ADMINISTRATIVE AMENDMENT (PD) ADD2025-00246

ADMINISTRATIVE AMENDMENT
LEE COUNTY, FLORIDA

WHEREAS, Sapien Site Planning, LLC, filed an application for an administrative amendment to a Mixed Used Planned Development (MPD) known as Bayshore 57 MPD to:

Samville Alignment

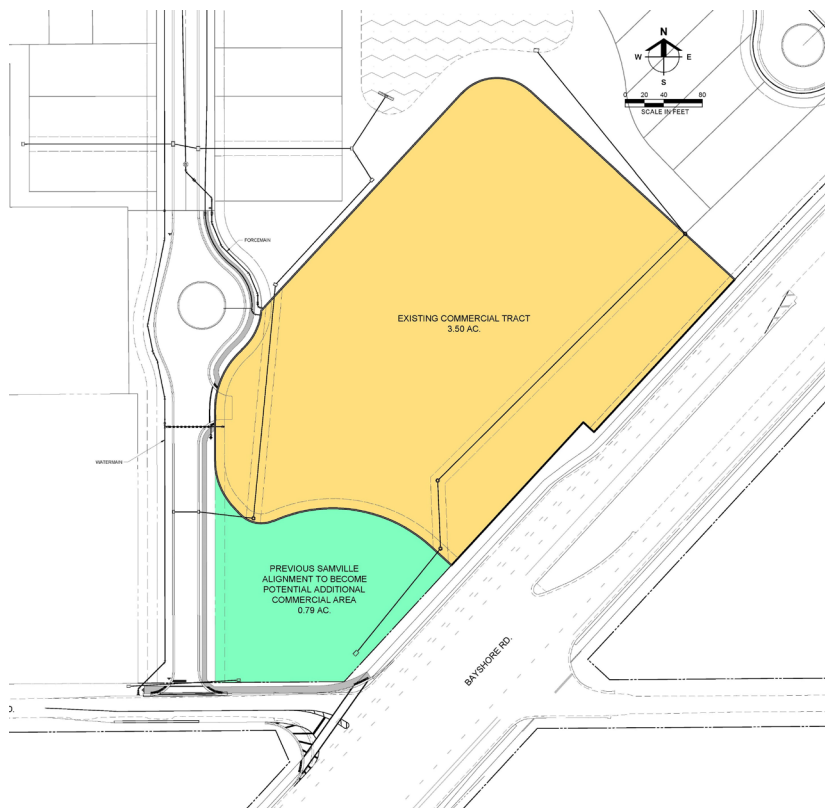
The current phase of development is in the southwest corner and includes the western access point for the project. To gain access to Bayshore Road, the approved MCP realigns Samville Road. Condition 12 of zoning resolution Z-10-002 states that “access to Bayshore Road/State Road 78 is not guaranteed and is subject to Florida Department of Transportation approval.” During FDOT permitting two things were determined:

1. FDOT will not approve the realignment of Samville Road;
2. FDOT will likely support a right-in / right-out for the commercial parcel on Bayshore Road.

As shown in the map to the right, holding the existing Samville Road alignment increases the commercial parcel by +/-0.8 acres.

Second Access

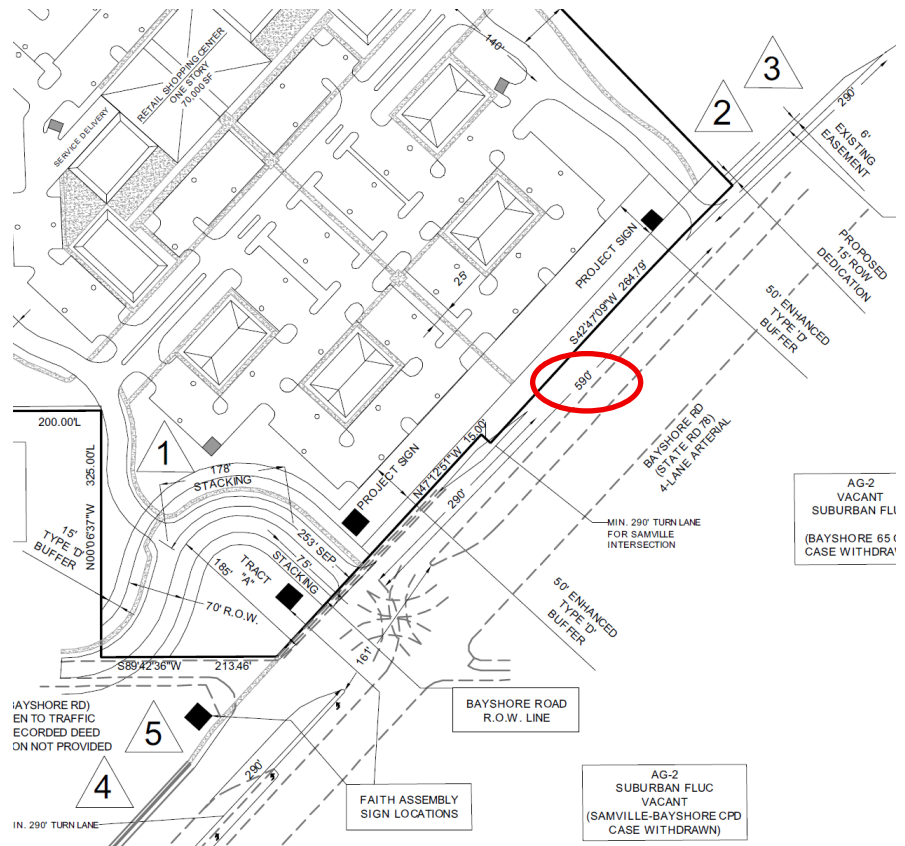
The Master Concept Plan within resolution Z-10-002 approved two access points on Bayshore Road. ADD2021-00214 renamed the approved MCP to Alternate A and added a second MCP, Alternate B. The project has been developed in accordance with MCP Alternate B.

Alternate A, the original approval, included two entrances to gain access to Bayshore Road. As discussed above, the first is through the realignment of Samville Road. As shown in the map to the right, the second access is in the southeast corner of the project. While no deviation was requested at the time, the MCP approved an intersection separation of 590-feet.

This ADD seeks to apply the eastern access point that was approved in Alternate A to Alternate B. The proposed right-in/right-out access isn't in the same location, but rather, it holds the 590-foot intersection separation to Samville Road.

Proposed MCP

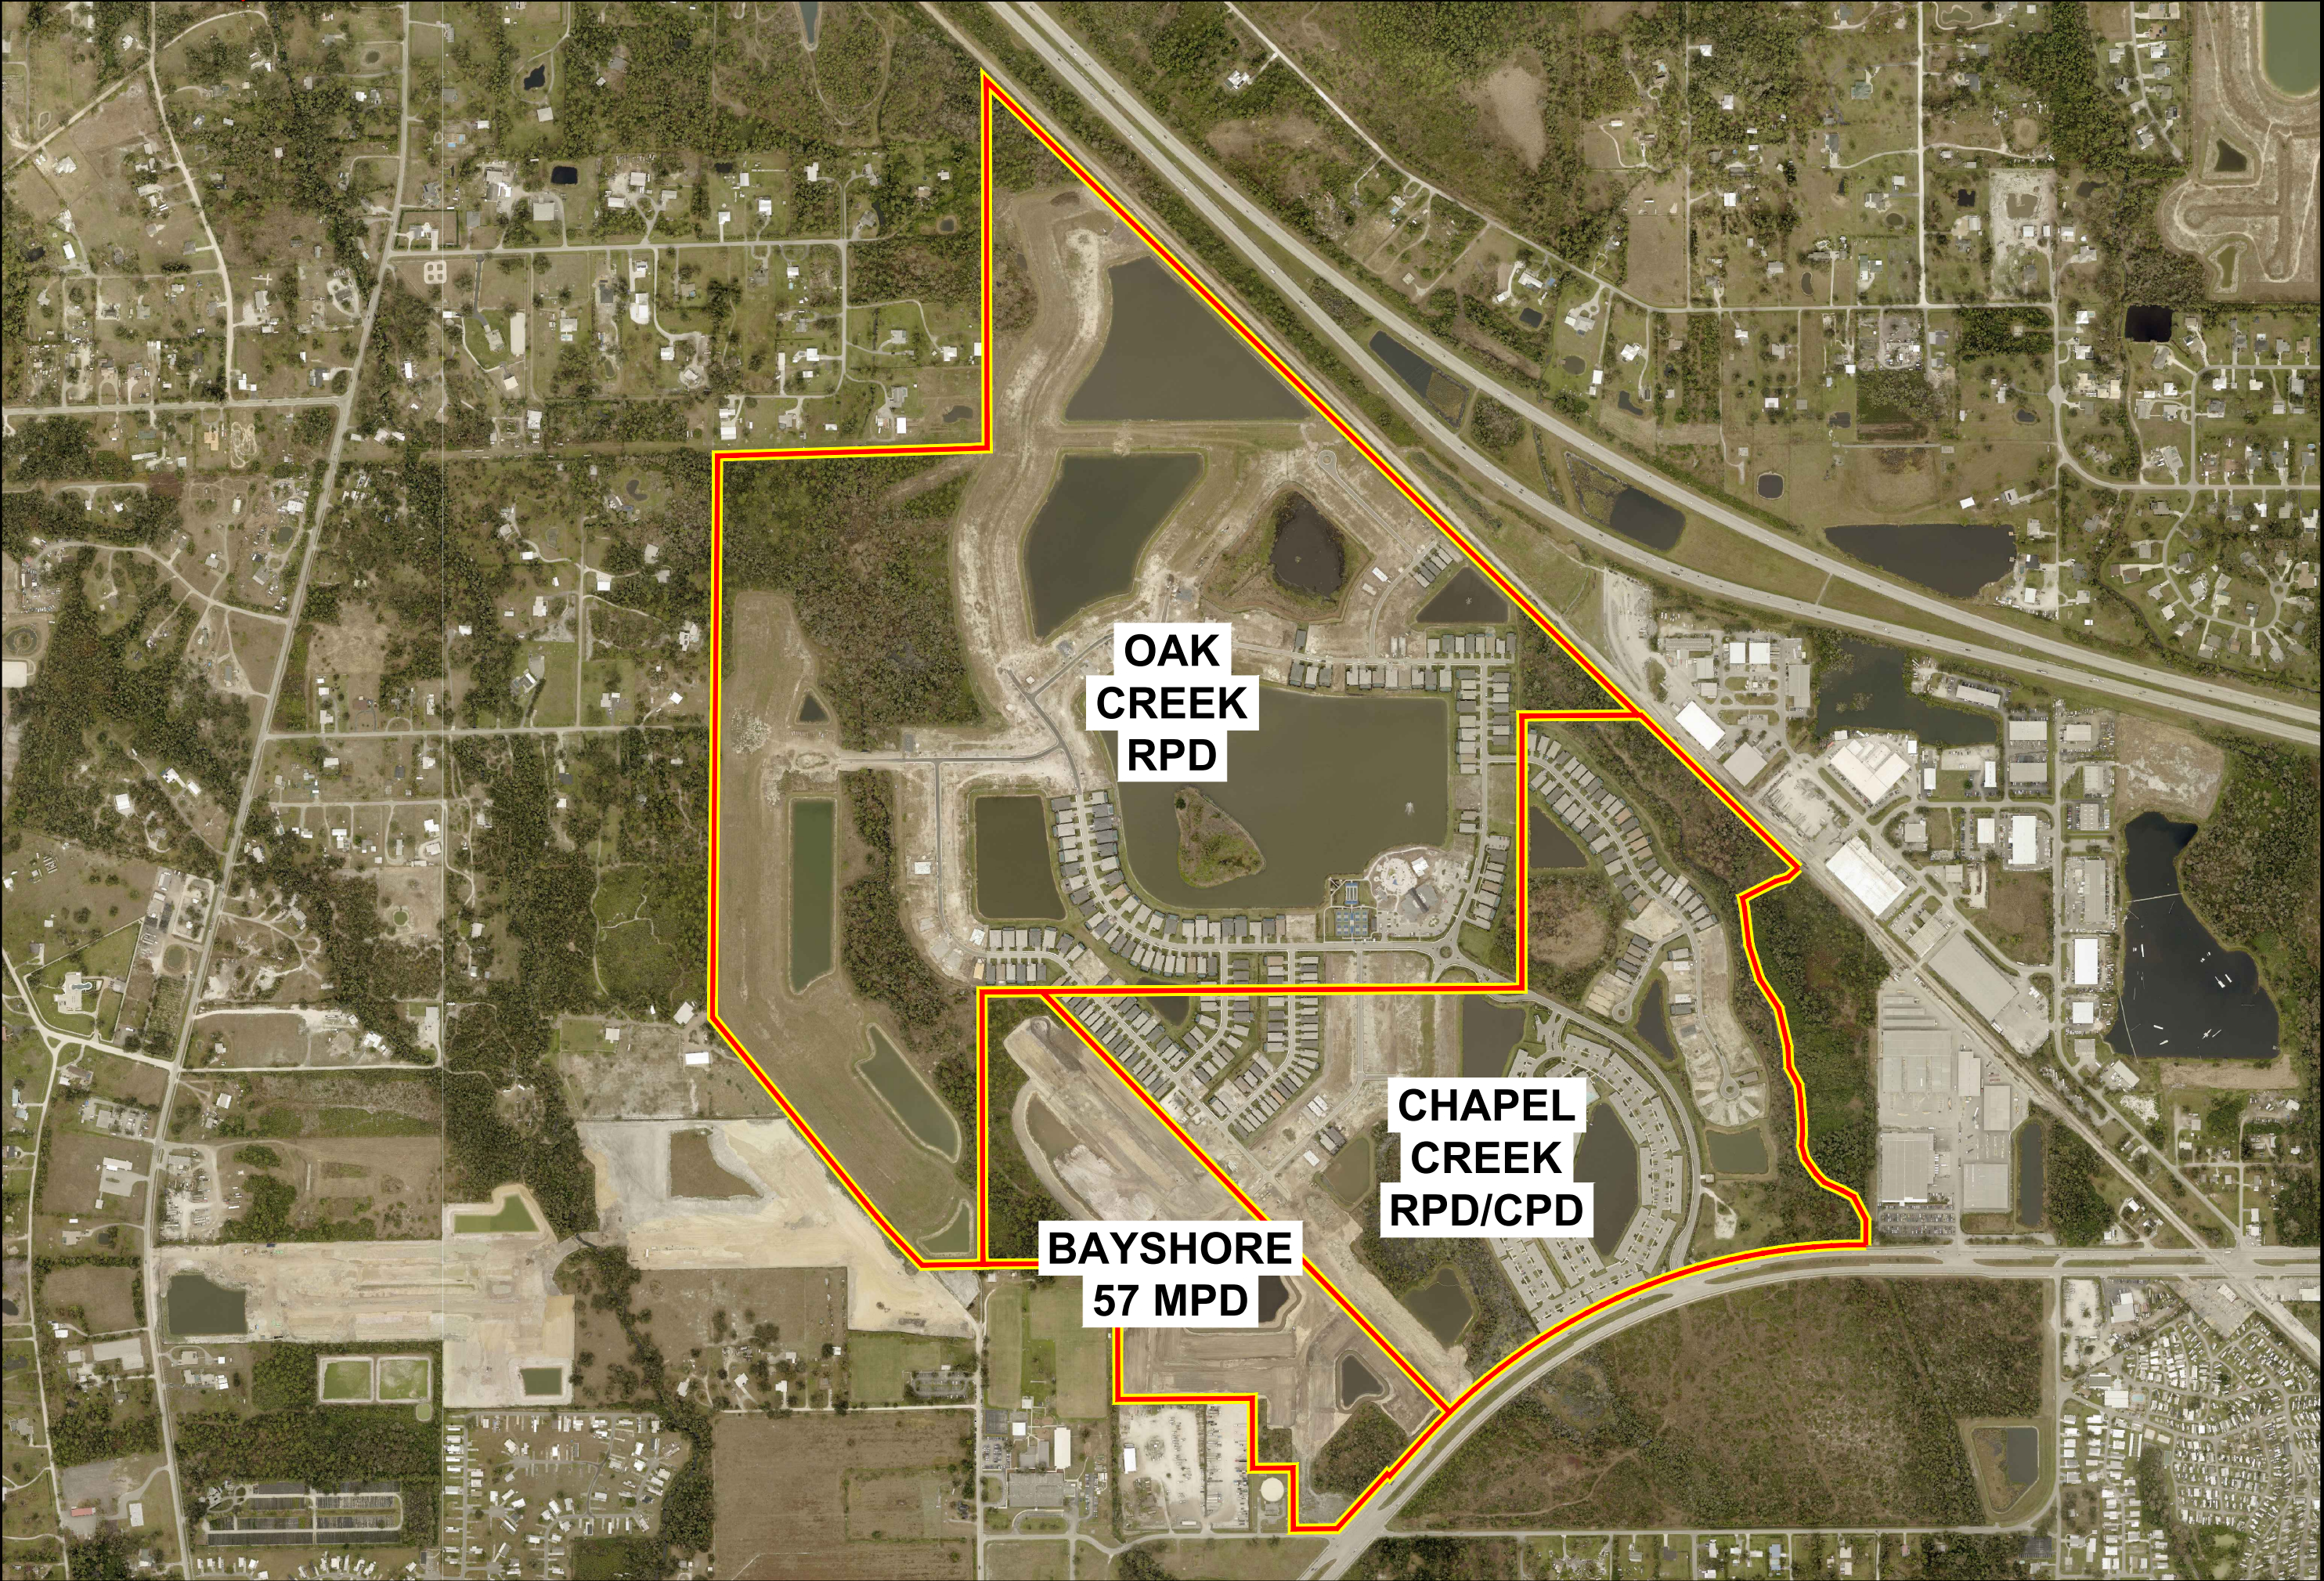
- Samville Road to remain as-is
- Creates 0.79 ac additional commercial and eliminates Tract A
- 3 access points:
 - On Samville Road loop – intersection separation reduced to 135’ (Revision to Dev #1)
 - Connections to Chapel Creek to Bayshore Road
 - Right-in / Right-out from Bayshore Road
 - Maintains 590’ intersection separation to Samville Road approved in MCP Alt A
 - Deviation requested to codify approval from MCP Alt A (Dev #13)
- Insufficiency letter (12-19-25): LDOT has no objections to Deviations 1 and 13.
